Office Action Summary	Application No. 10/521,431	Applicant(s) SATO ET AL.	
	Examiner Alan B. Waits	Art Unit 4112

DETAILED ACTION

5. Claims 1-4 are rejected under 35 U.S.C. 102(b) as being anticipated by Mentani et al. USP 4425770.

Fig. 2

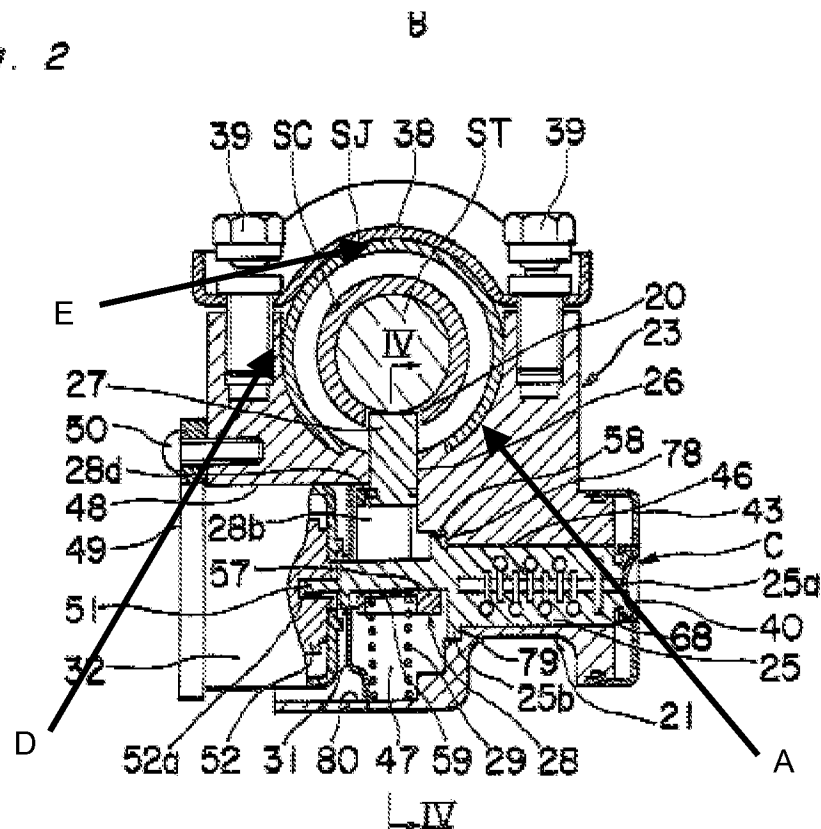
- Steering column (fig 2 below) provided with a steering lock mount portion (SJ, fig 2 below) on its outer circumference and supporting a steering shaft rotatably (ST, fig 2 below)

- Steering lock (bottom portion of fig 2) having a lock key (36, fig 3) for latching said steering shaft (ST, fig 2 below) and a contact portion (A, fig 2 below) that is in contact with a part of said steering lock mount portion (SJ, fig 2 below) of said steering column (fig 2 below)

- Lock bracket (38, fig 2 below) having a contact portion (E, fig 2 below) that is in contact with another part of said steering lock mount portion (SJ, fig 2 below)

- Contact portion (A, fig 2 below) of said steering lock (bottom portion of fig 2) and said contact portion (E, fig 2 below) of said lock bracket (38, fig 2 below) embracing said steering lock mount portion (SJ, fig 2 below) of said steering column (fig 2 below)

- Steering lock mount (SJ, fig 2 below) of said steering column (fig 2 below) abuts at least one of said steering lock (bottom portion of fig 2) and said lock bracket (23 and 38, fig 2 below) with an abutting surface having a non-circular cross section (D, fig 2 below)

- Steering lock mount portion (SJ, fig 2 above) abuts said steering lock (bottom portion of fig 2) with a circular cross section (A, fig 2 above)
